Water License Pre-Hearing Technical Meeting Information Supplement

**Doris North Project
Nunavut, Canada**

June 2007

The following supplemental information is provided in response to the Table of Issues generated during the Doris North Pre-Hearing Technical Meeting held in Cambridge Bay on June 11th and 12th, 2007.

Figure 6: Ventilation Raise Access Road Layout

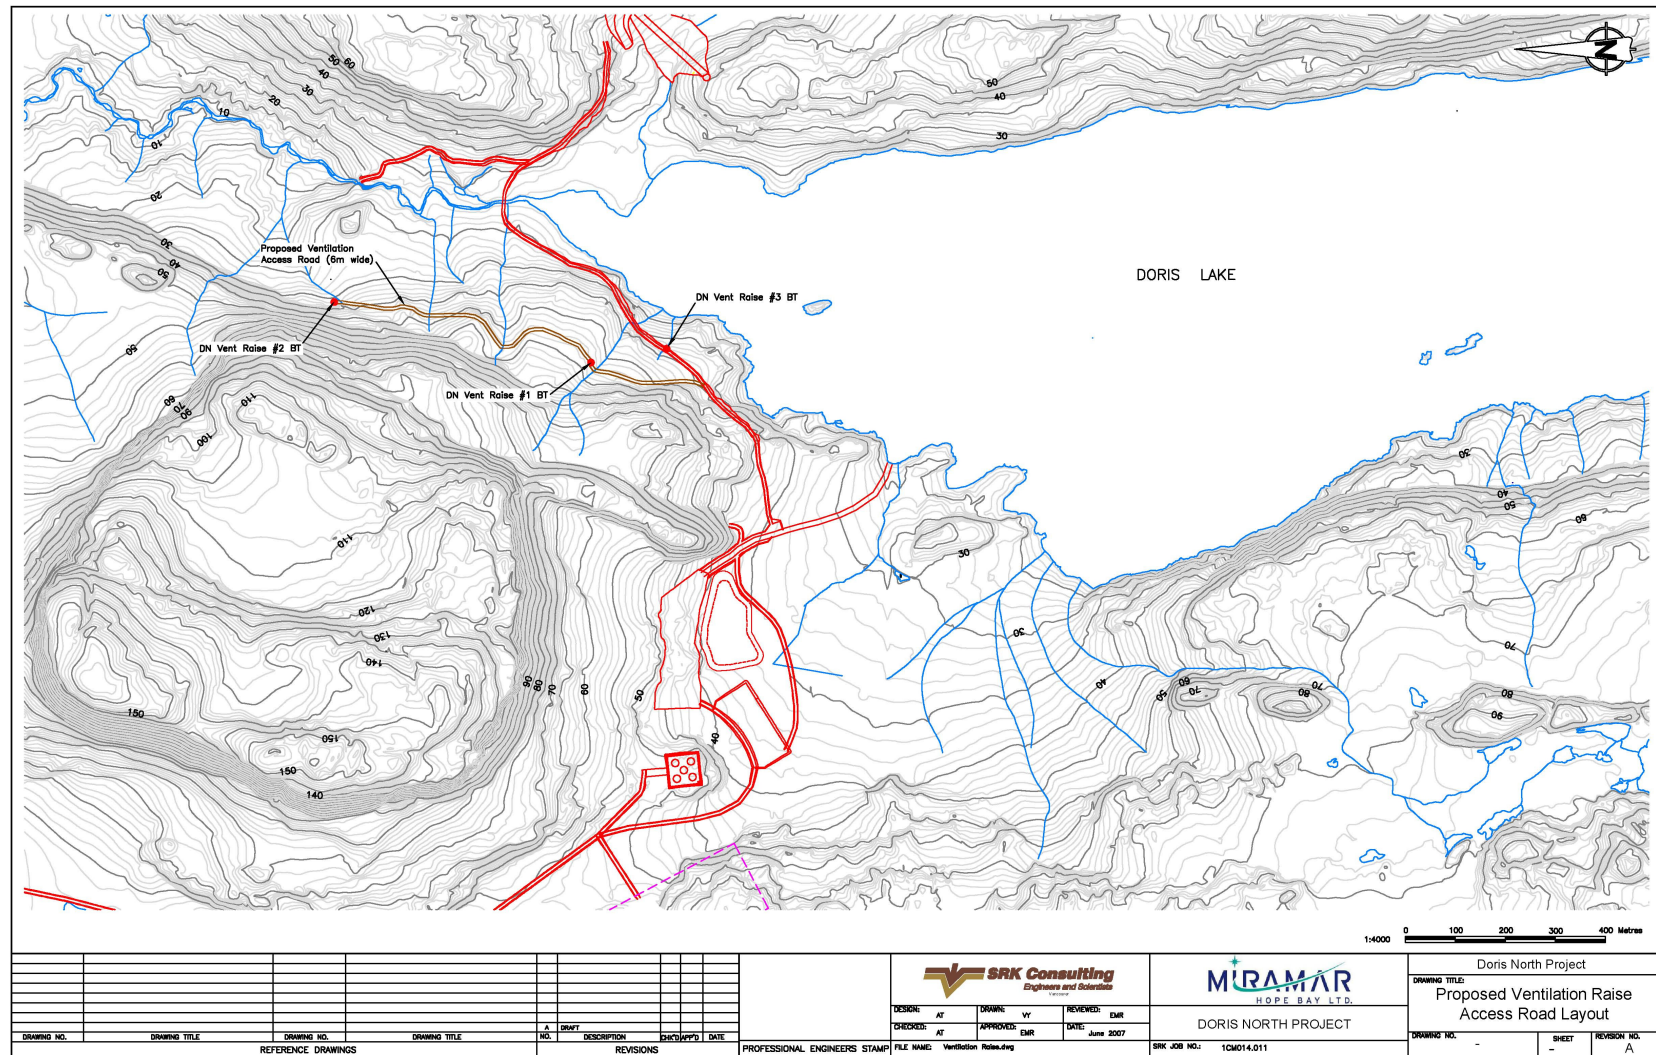
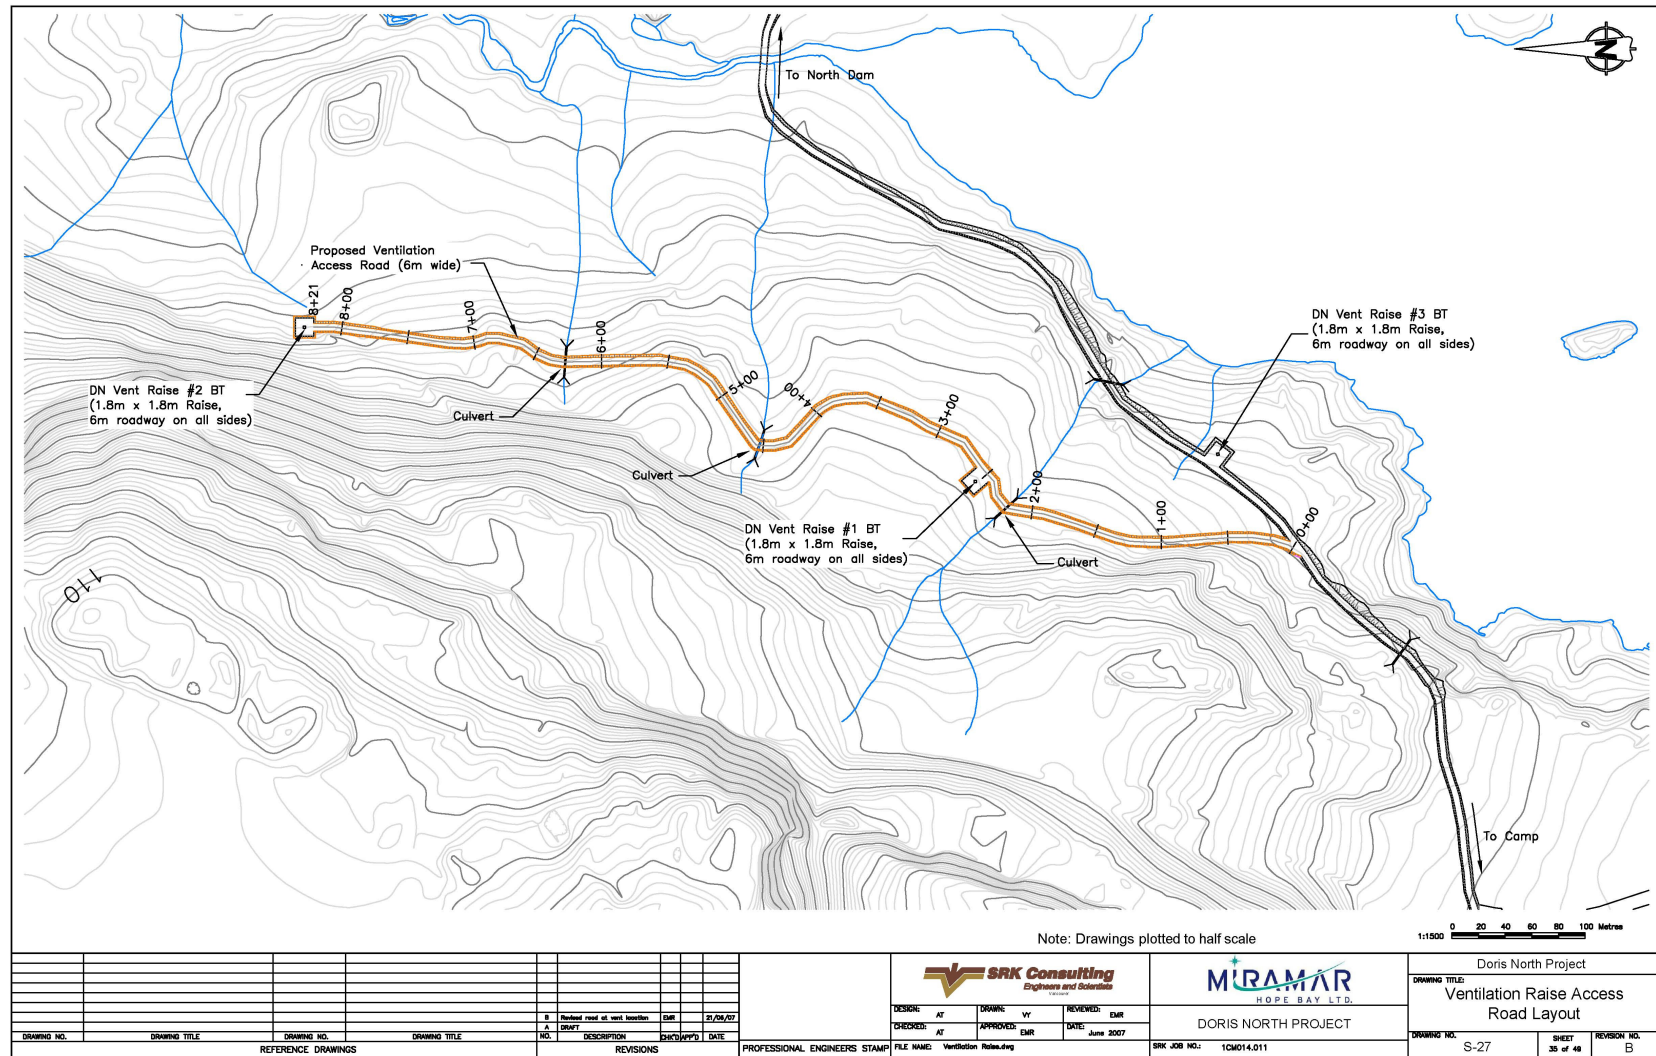
An 800 m long x 6 m wide service road will have to be constructed to allow maintenance access for these fans at Vent Raise #1 and #2. The road will run to the northeast of the mine portal along the east side of the mesa as shown in the attached Figure 5. This new road will add an additional 0.48 hectares of surface disturbance to the overall project footprint of 62 hectares. Raise #3 will be accessed from the main road going to Tail Lake. This service road will see minimal traffic (estimated at 1 vehicle trip per day) but will also allow for a secondary egress route from the mine for mining personnel in the event of an underground emergency that may block safe access up the ramp. This road was inadvertently overlooked by MHBL during the assessment phase although the ventilation fans were included in the assessment. The detailed road layout is shown on the SR Drawing S-27 – Ventilation Raise Access Road Layout (Figure 6). The three stream crossings shown on the SRK Drawing are all ephemeral drainage runoff paths and do not represent year round streams and thus do not allow for fish access. MHBL proposes that rock drains be installed at these three points to allow unimpeded passage of surface runoff through these drainage pathways.

Figure 7: Sanibrane STP Flowsheet

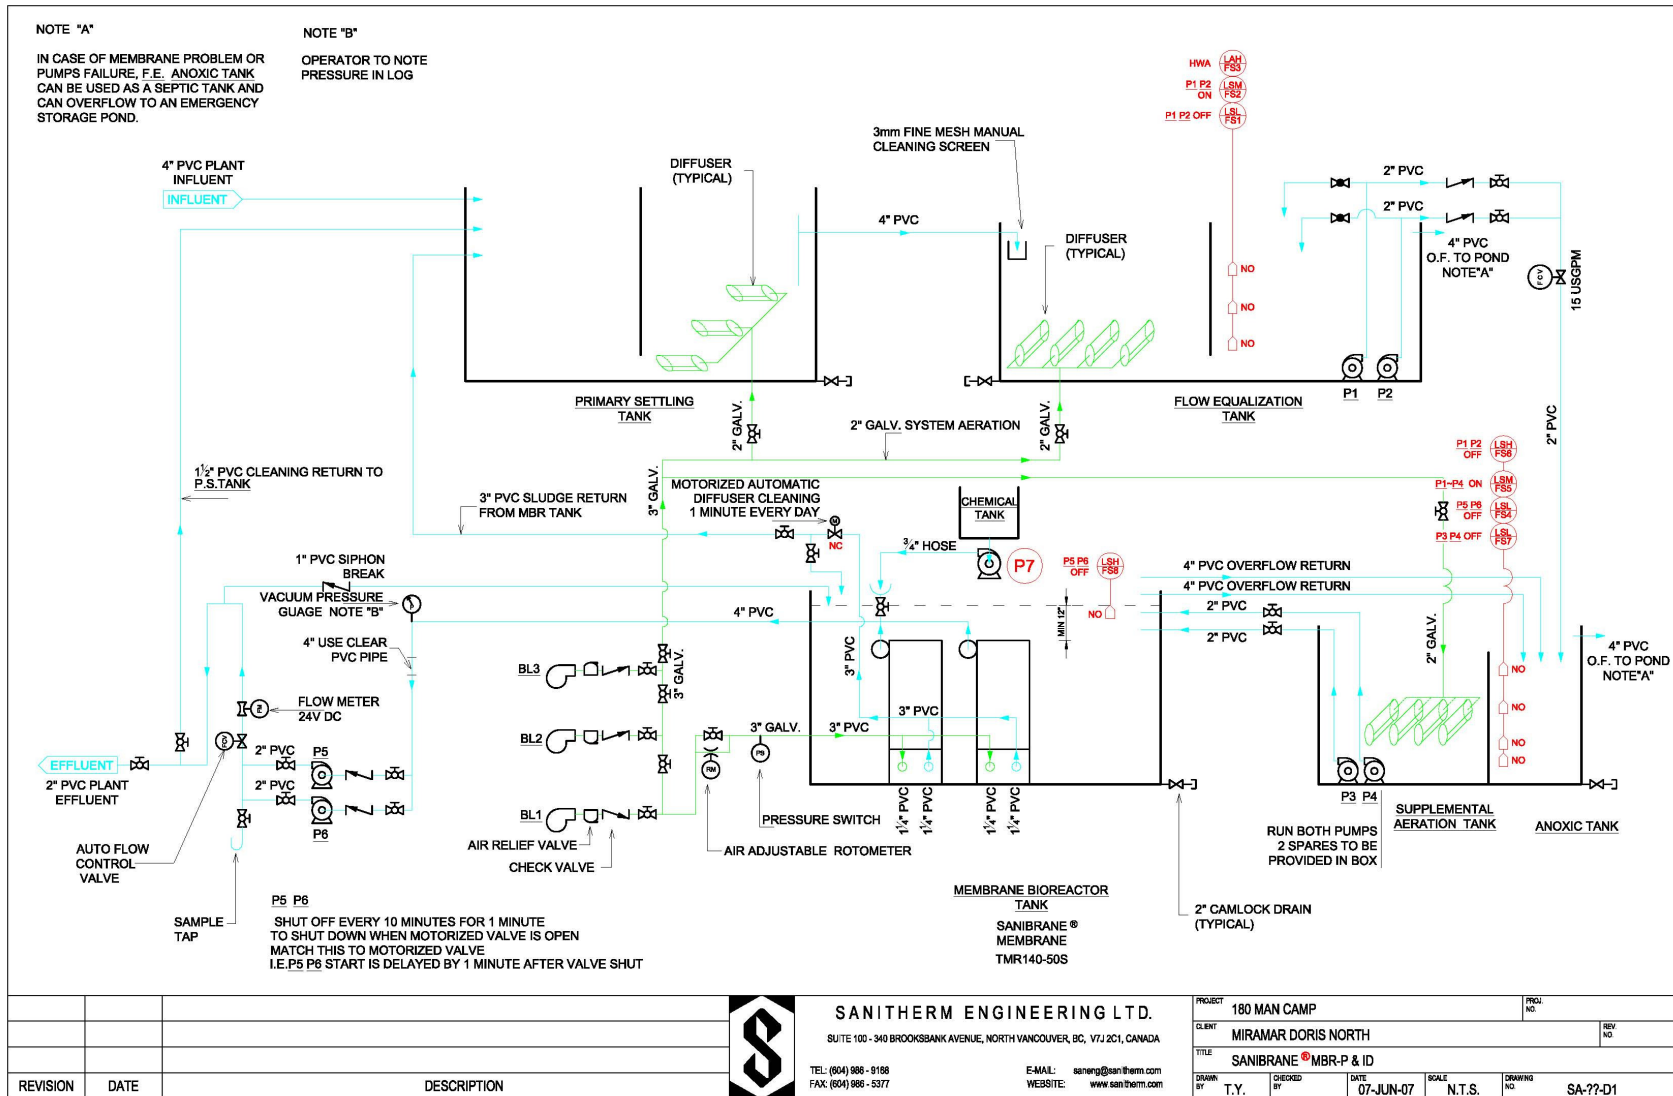
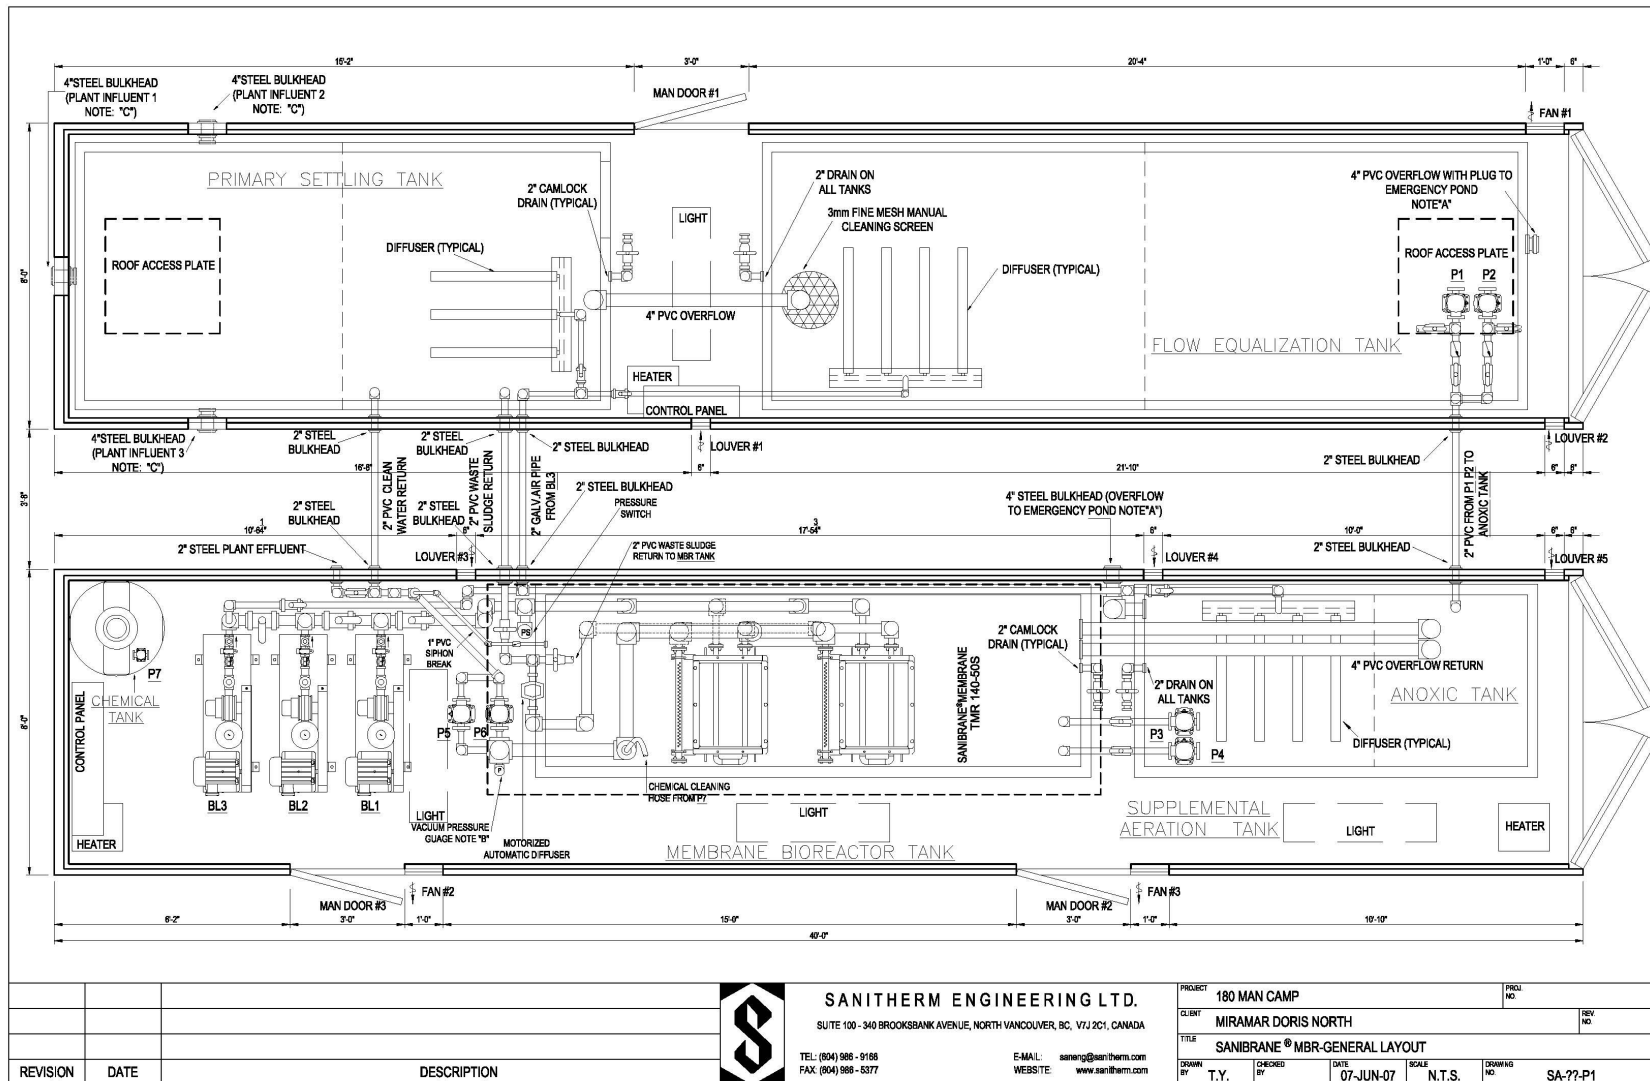
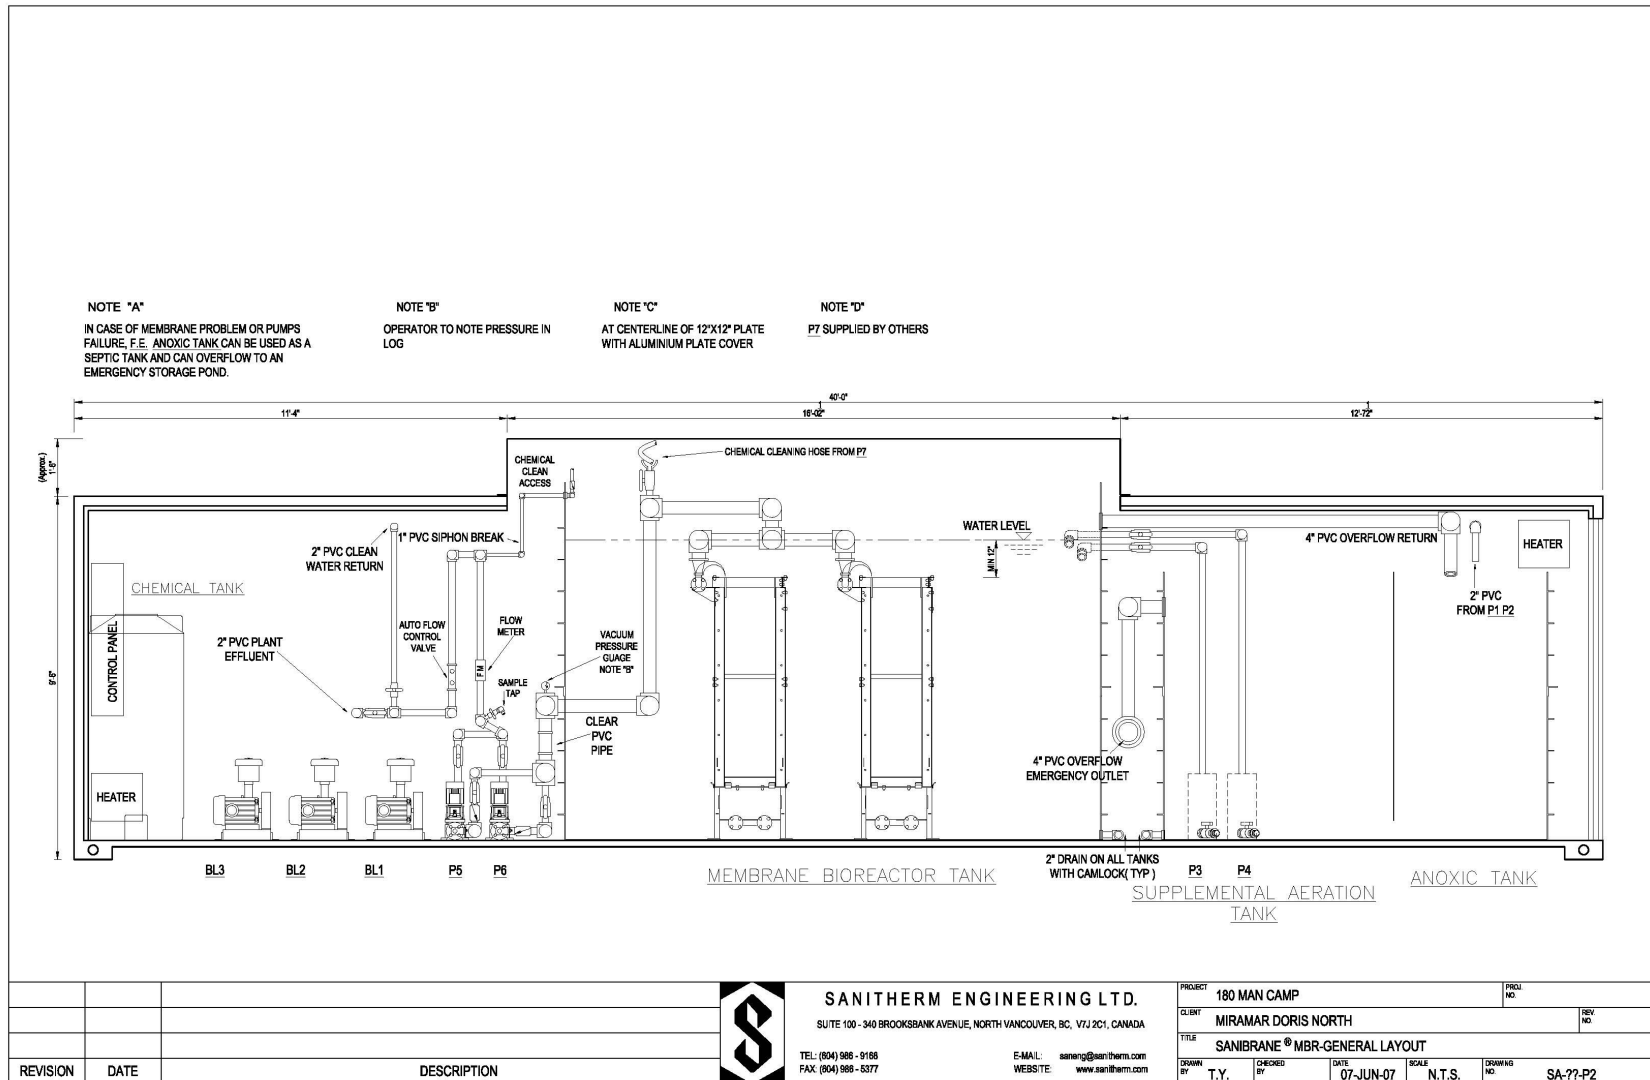
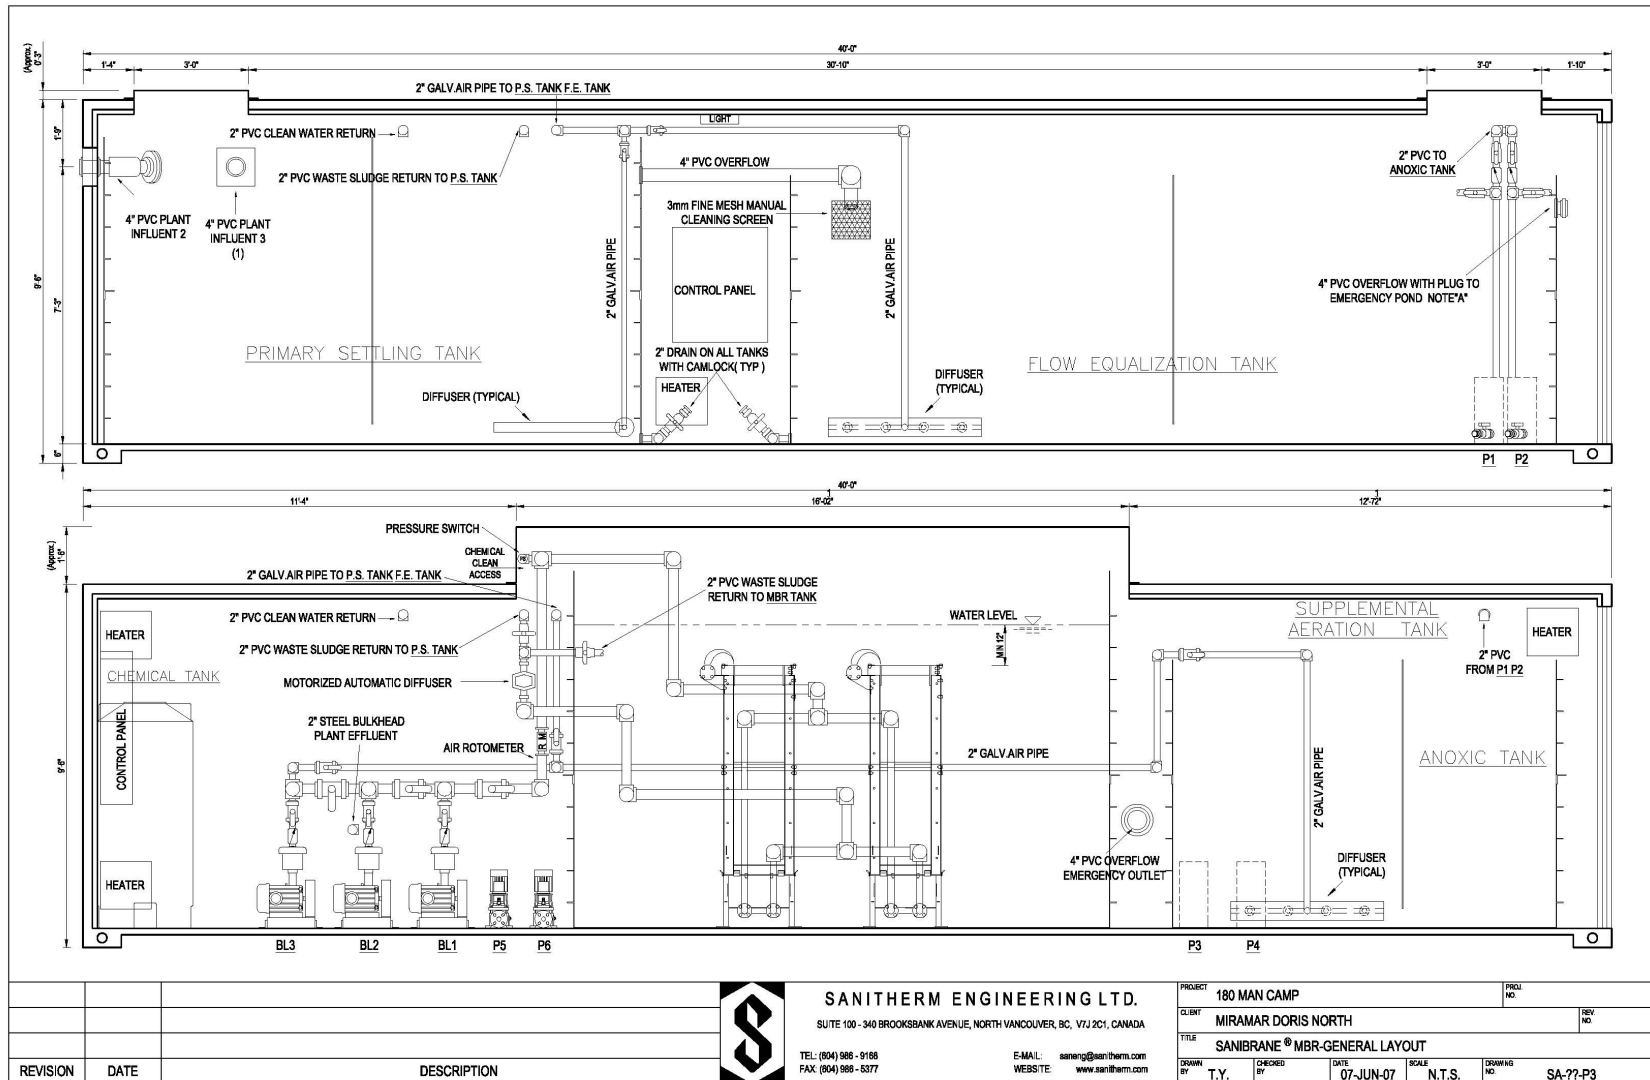
Based on a recommendation from SNC-Lavalin, MHL has proposed that the Doris North packaged sewage treatment plant (STP) be changed from a rotary biological contactor type of plant as described in the April 2007 Water License application to a SaniBrane Membrane bio reactor similar to the units installed at the Snap Lake and Diavik Diamond Mine Projects. These newer membrane bioreactor sewage treatment systems are reported to be easier and cheaper to maintain and operate in northern climates and achieve better treatment levels than the rotary biological contactors. A flowsheet for the proposed Doris North

Membrane Bio-reactor STP is presented in Figure 7. The STP would come to site pre-constructed inside two 12m (40') long shipping containers. A plan view of this STP arrangement is presented in Figure 8. Cross-sectional plans for the two containers are presented in Figure 9 and 10, respectively.
